**From:** Lein, Jerry R.  
**Sent:** Monday, August 02, 2010 1:39 PM  
**To:** 'Kevin Solie'  
**Cc:** -Grp-PSC Commissioners; -Grp-PSC Legal; -Grp-PSC Public Utilities  
**Subject:** FW: Williston-Tioga PU-07-671 Structure move request  
**Attachments:** 87-88.pdf; 101-105.pdf; 271-273.pdf

**From:** Kevin Solie [mailto:KSolie@bepec.com]  
**Sent:** Monday, July 26, 2010 8:36 AM  
**To:** Lein, Jerry R.  
**Subject:** Williston-Tioga PU-07-671 Structure move request

**68** **PU-07-671** Filed: 8/2/2010 Pages: 6  
**Staff approval of the transmission structure locations**

# Structures 87-88

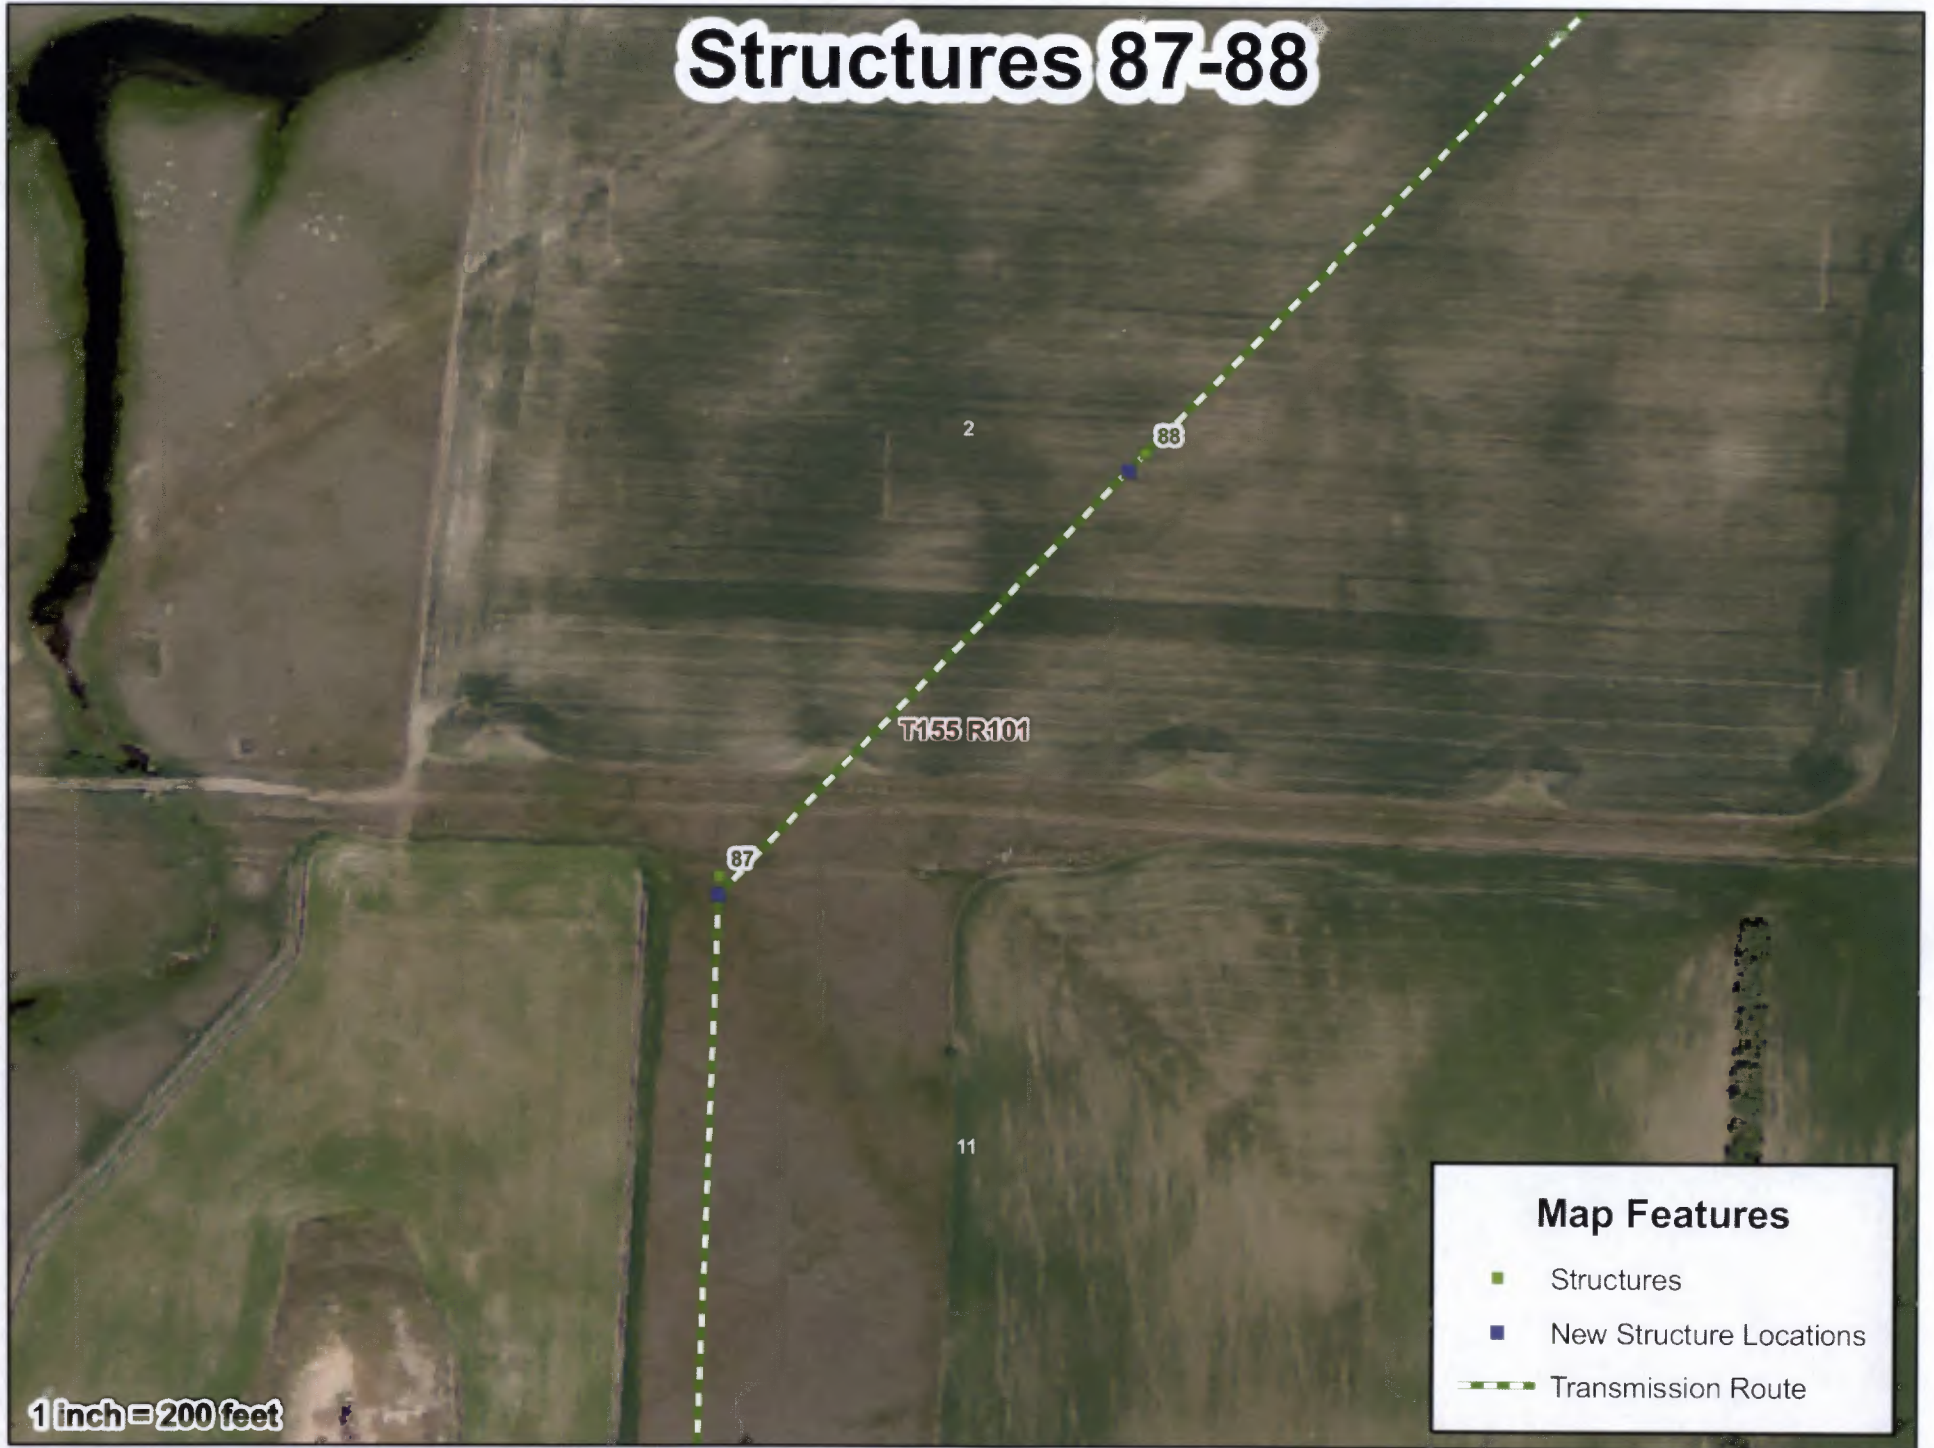
Structures 87-88 need to be moved on account of an oil pipeline easement.

Kevin – Please consider this e-mail to be staff approval of the transmission structure locations as attached and requested below. Thanks.

# Structures 101-105

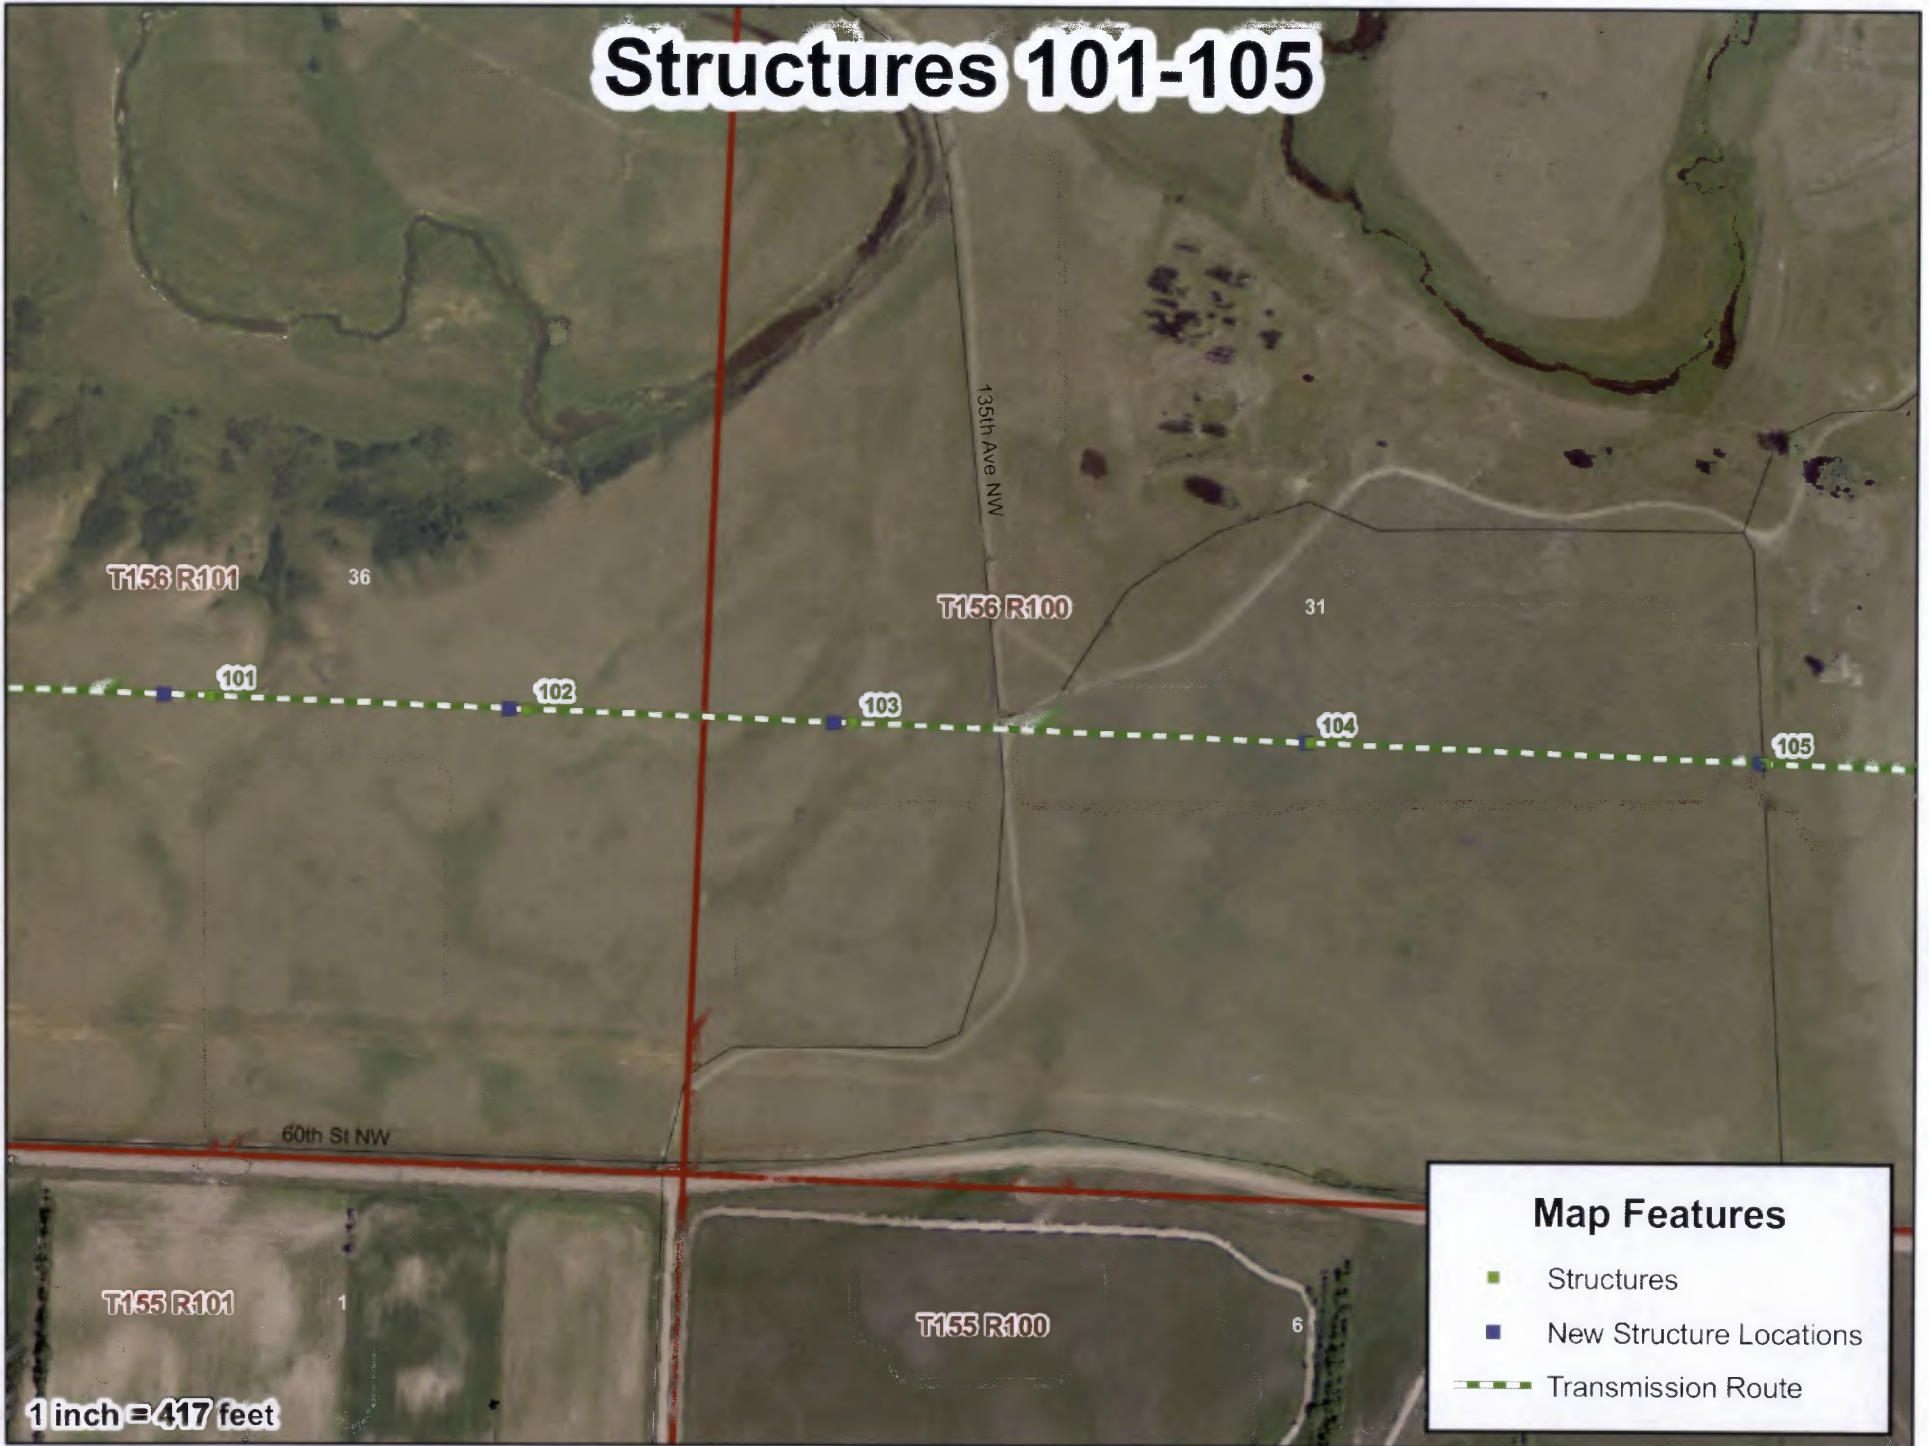
Structures 101-105 are all on the permitted centerline and need to be moved because of cultural resources; one structure move (101) caused a ripple effect.
